STONEY WOOD QUARTER, THE FAIRWAY, THE LONDON BOROUGH OF BARNET

DESIGN AND ACCESS STATEMENT ADDENDUM

This Design and Access Statement Addendum has been split into two parts. The first (sections 2-5) covers the changes that have been made to the proposed scheme since the original December 2025 submission. The second (sections 6-13) addresses the additional information and clarifications sought from the GLA during the Stage 3 process in respect of the residential redevelopment of Stoney Wood Quarter (LPA Ref 25/2743/FUL).

Block D – Lower Ground and Ground Floor Plans

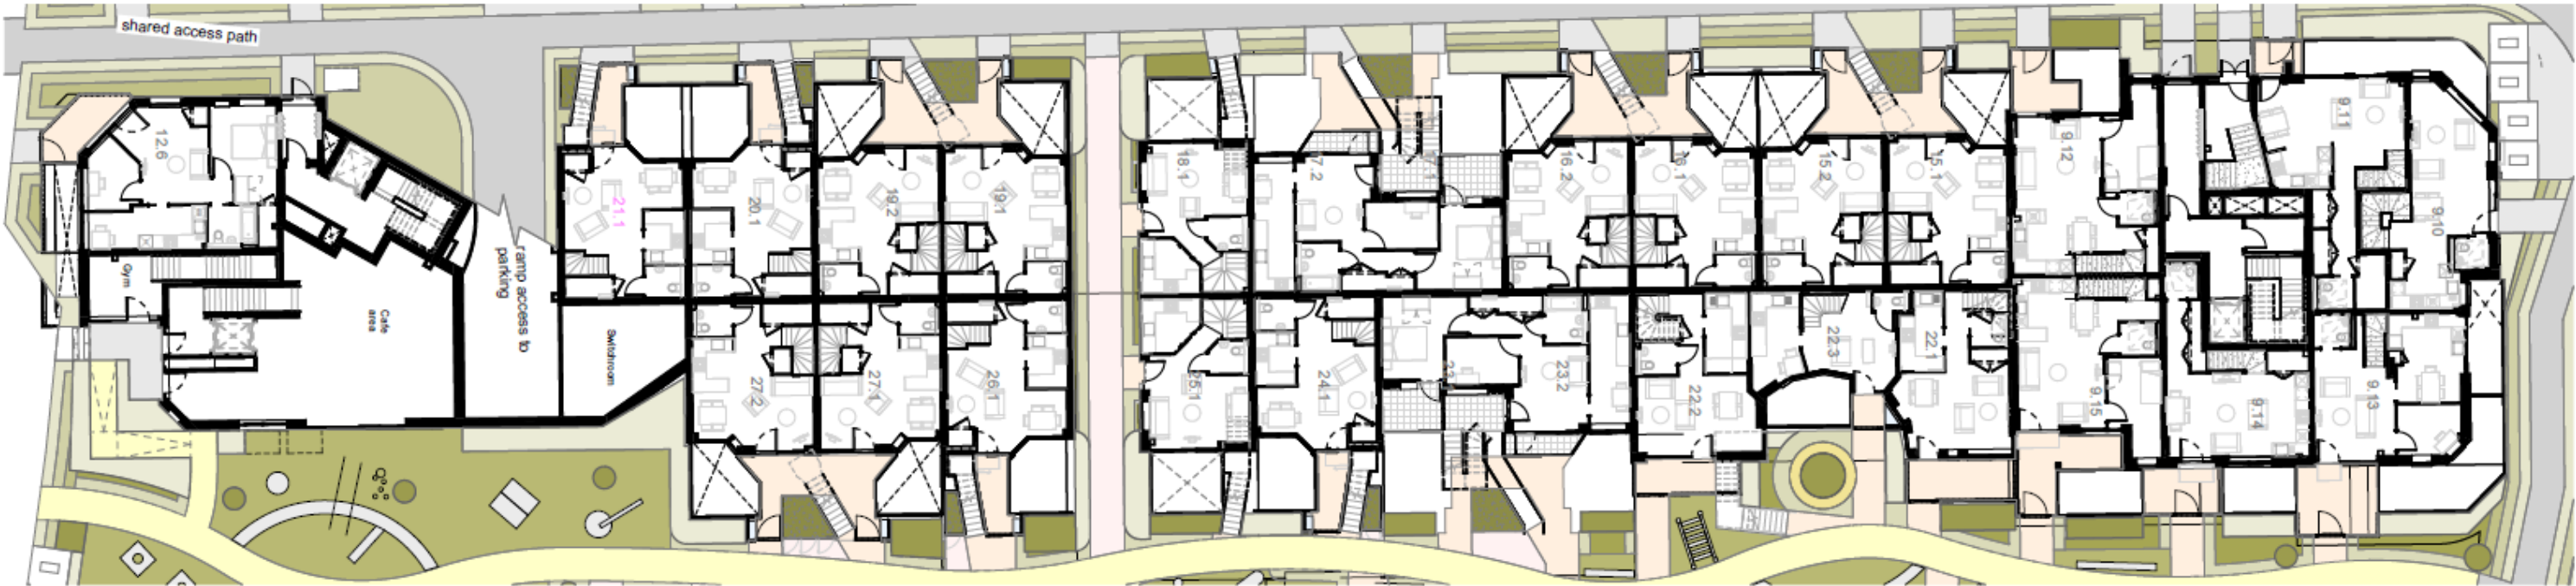
The revised block plans develop the submitted scheme to the level of detail required at RIBA Stage 4. They have been developed as a single exercise, so that façade depth, the articulation and stepping-back of upper floors, and the placement of windows, entrances and terraces read according to the design intent in plan and elevation.

The basement has been rationalised and used more efficiently to enhance the resident's amenities, including additional community space, incorporate a postal delivery room, and increase the plant provision to meet the RIBA Stage 4 plant specifications for the buildings.

The following page provides examples of the minor changes that have been made to typical lower ground, ground and upper floors of the buildings. A revised set of plans have been submitted as part of the revised application submission.

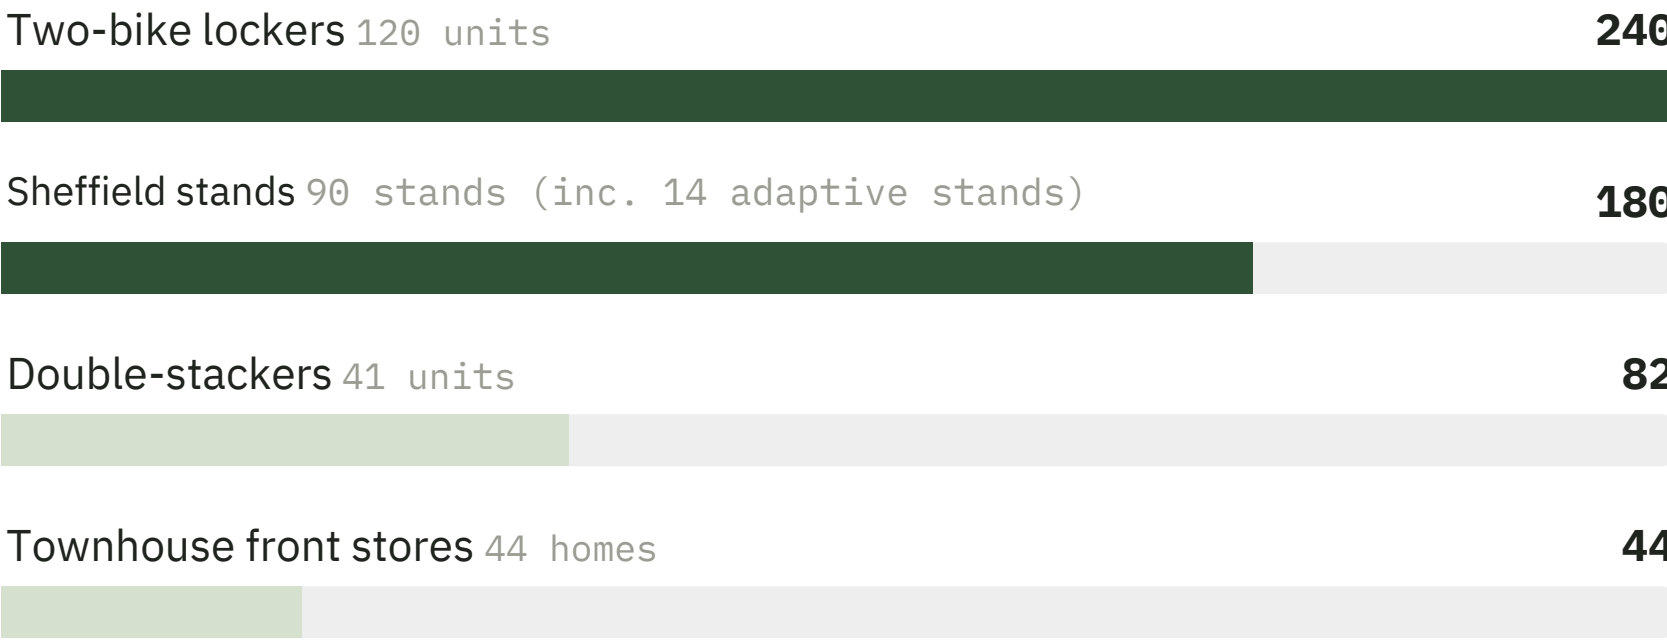
Whilst the quantum of cycle parking has been reduced from 843 long stay and 13 short stay to 546 long stay and 23 short stay the quality has been enhanced with a shift from being nearly entirely double stacker provision to a mix of bike lockers, Sheffield stands, stackers and stores in front of houses.
